UNITED STATES PATENT AND TRADEMARK OFFICE

APPLICATION NO.	FILING DATE	FIRST NAMED INVENTOR	ATTORNEY DOCKET NO.	CONFIRMATION NO.
10/692,487	10/27/2003	Kent J. Myers	KMY.P.0003	1972
7590 06/16/2004			EXAMINER	
Mark L. Weber Renner, Kenner, Greive, Bobak, Taylor & Weber First National Tower Fourth Floor Akron, OH 44308			NGUYEN, PHONG H	
			ART UNIT	PAPER NUMBER
			3724	
DATE MAILED: 06/16/2004

Office Action Summary

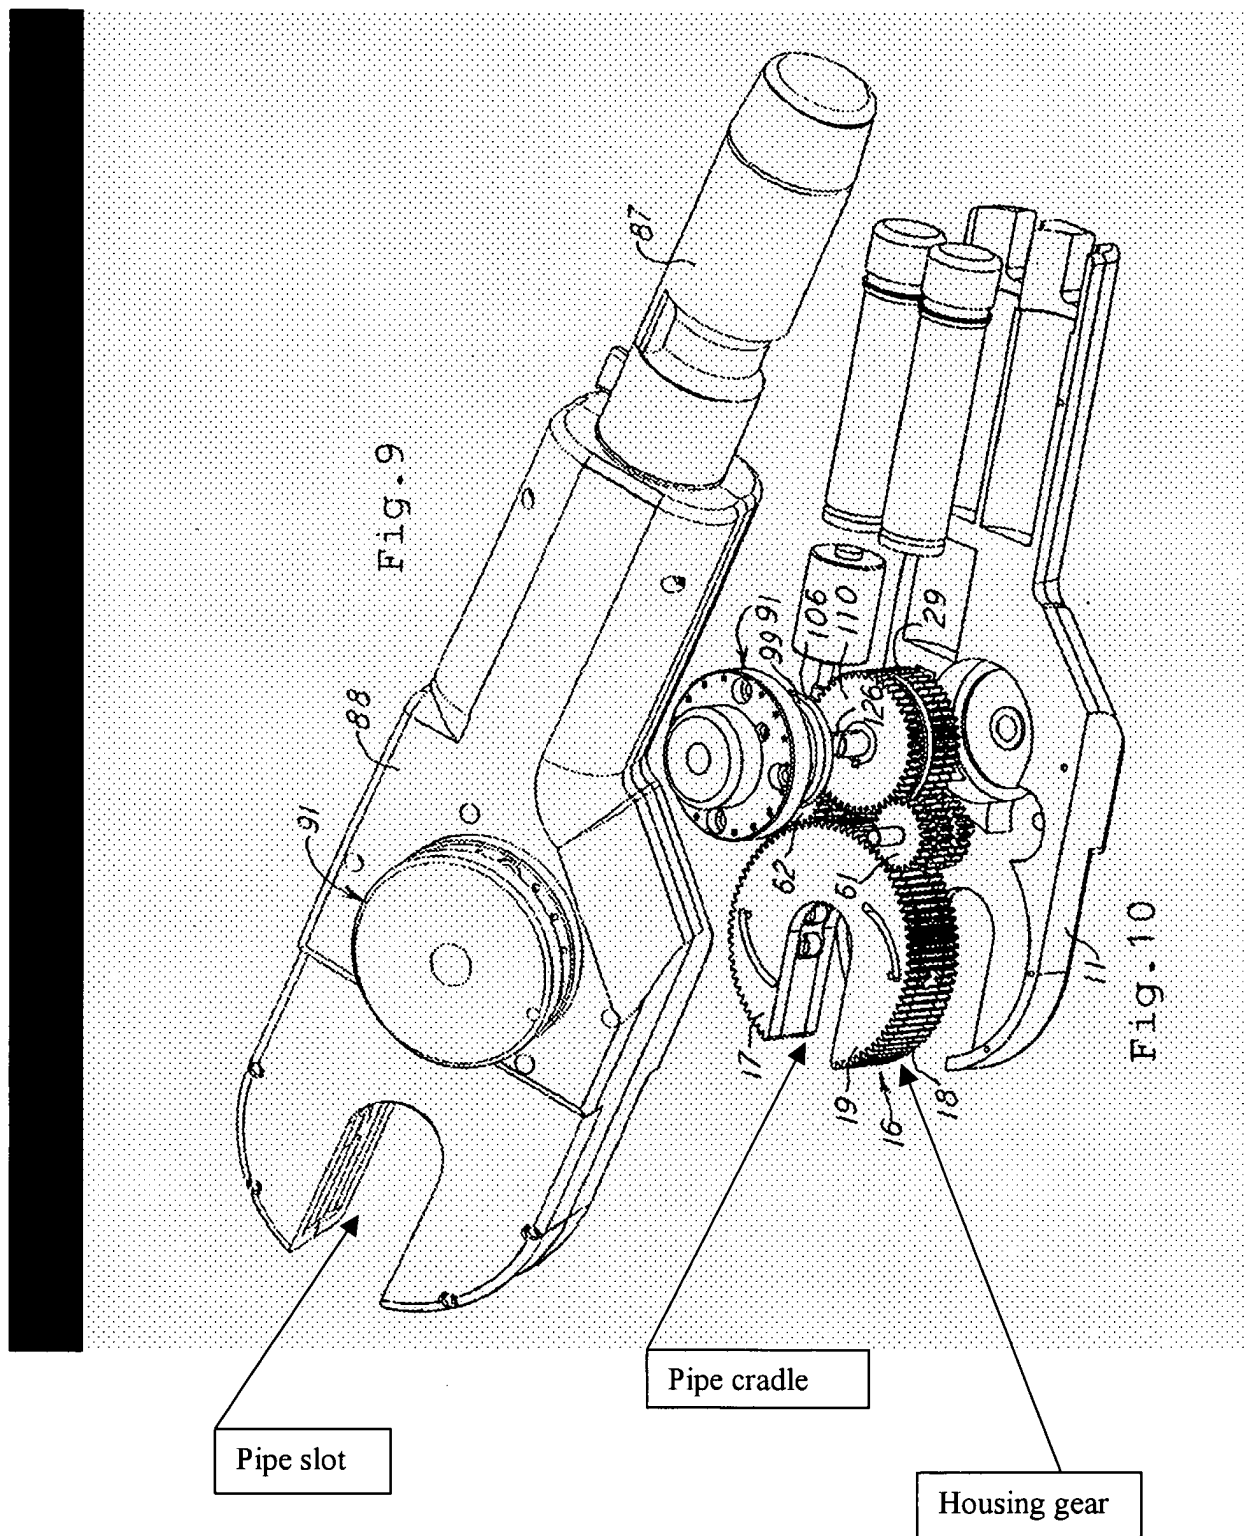
Regarding claims 1-3 and 16, Lazarevic (6,065,212) teaches all the recited elements of the invention including a pipe cutter device comprising a rotary head 16, a housing gear, a pipe slot, a pipe cradle, a cutting wheel 37, wheel biasing members 57

and 59, a drive source 26 and a gear system comprising a prime gear 64, a first drive gear 61 and a second drive gear 62. See Figs. 1-18.

Regarding claim 4, a slot-engaging gear 31 is best seen in Fig. 1. The teeth of the gears are considered as protrusions. During the rotation of gear 31 and the housing gear, the protrusions engage the pipe slot.

Regarding claim 13, two freewheeling support rollers 52 are best seen in Figs. 6, 11, 16 and 18.

Regarding claim 14, an adjustable block 46 is best seen in Fig. 11.

Regarding claim 15, pipe-engage-surfaces 52 are best seen in Fig. 11, 16 and 18.

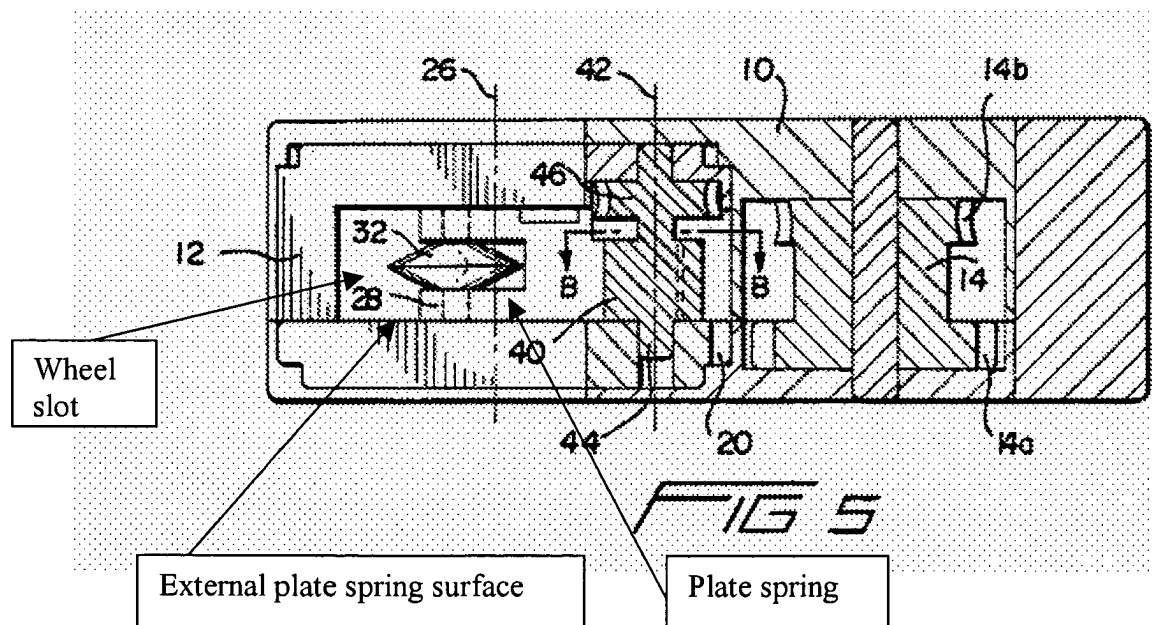
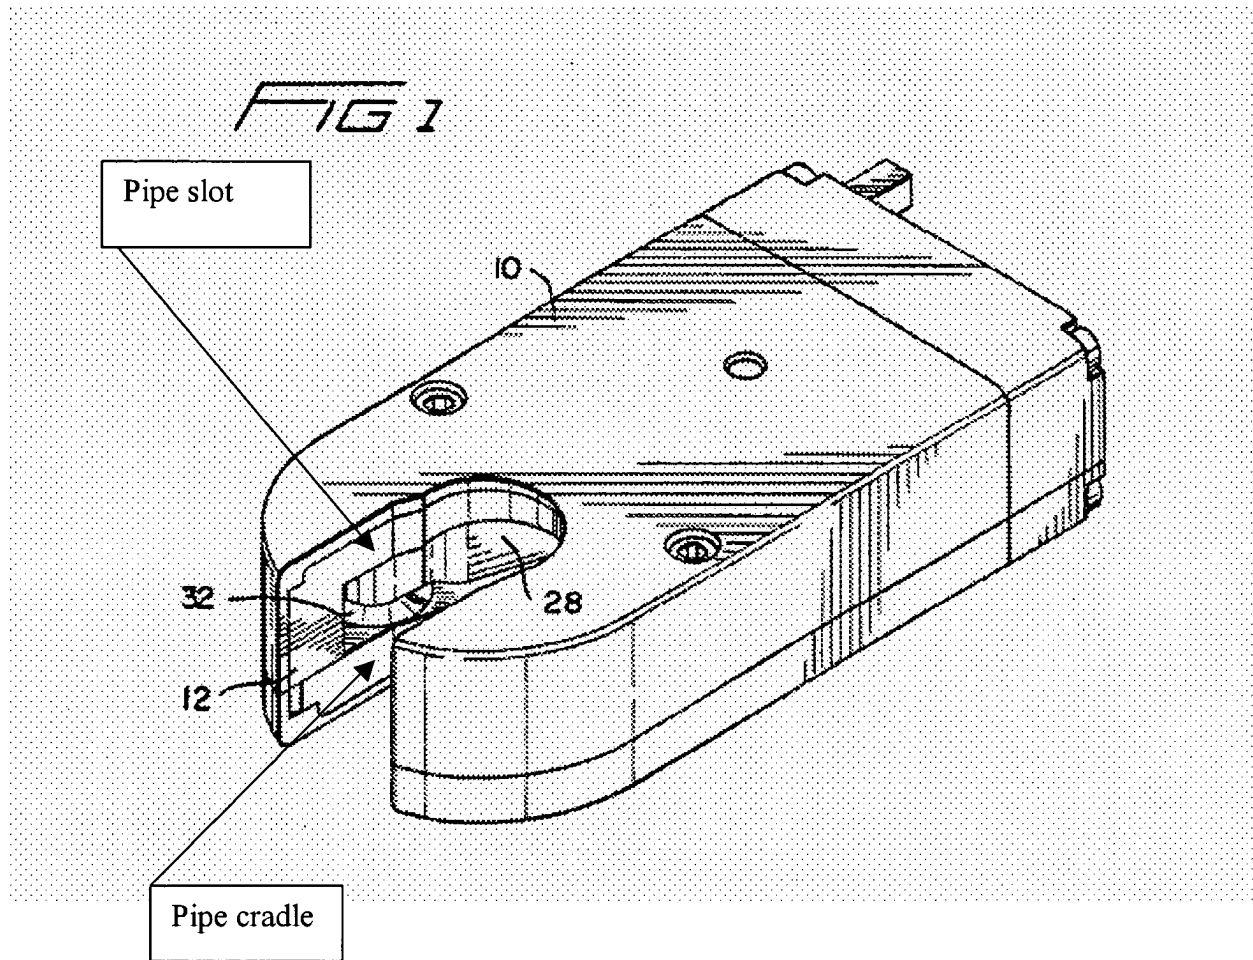
Regarding claims 1-4 and 16, VanderPol et al. teach all the recited elements of the invention including a pipe cutter device comprising a rotary head 12, a housing gear 20, a pipe slot, a pipe cradle, a cutting wheel 32, a wheel biasing member comprising elements 28, 30 and 36 and a drive source inherently in the pipe cutting assembly. See Figs. 1-8.

A slot-engaging gear comprising gears 16 and 18 is best seen in Fig. 3. The teeth of gears 16 and 18 are considered as protrusions. During the rotation of gears 16 and 18 and the housing gear 20, the protrusions engage the pipe slot.

Regarding claims 5, 6 and 7, the wheel-biasing member comprising two plates 28 to form a slot therein for receiving the cutting wheel and the spring 28 for disengaging the cutting wheel from the pipe is considered as a plate spring member since it performs the same claimed functions. The plates 28 support the freewheeling shaft of the cutting wheel and the spring 28 urges the freewheeling shaft via the plates 28. See Figs. 2, 4 and 5.

Regarding claim 10, the spatial relationship of the rotary head and the plate spring member is best seen in Fig. 5.
